27 October 2025

SSD-82599709
D109/2025/1
JD6 (P&E)

**STATE SIGNIFICANT DEVELOPMENT APPLICATION 82599709
153-157 WALKER STREET NORTH SYDNEY
MIXED USE DEVELOPMENT
FREECITY NORTH SYDNEY DEVELOPMENT PTY LTD**

Figure 1. An estimated 5,000 knowledge-intensive jobs are currently under threat from eight SSDs in the North Sydney LGA, representing an estimated loss of \$1.5 billion in GVA per annum, at time of writing

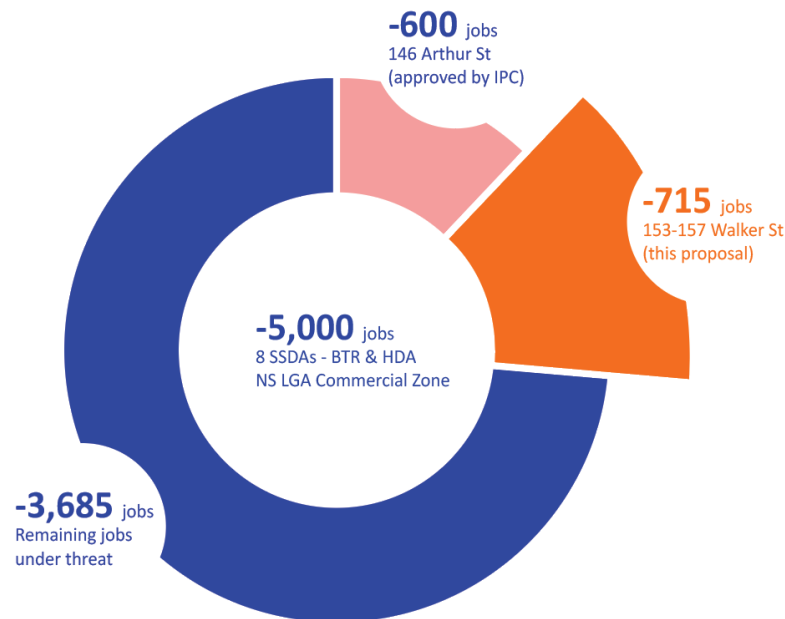
The first of these SSDs has now already been approved for **146 Arthur Street** by the Independent Planning Commission (IPC) ([IPC decision](#) 9 October 2025). This means that the recent planning reforms are already set to lose approximately **600 existing jobs** and associated output of **\$187 million** per annum in the CBD (Figure 1). The loss of planned capacity is significantly larger again.
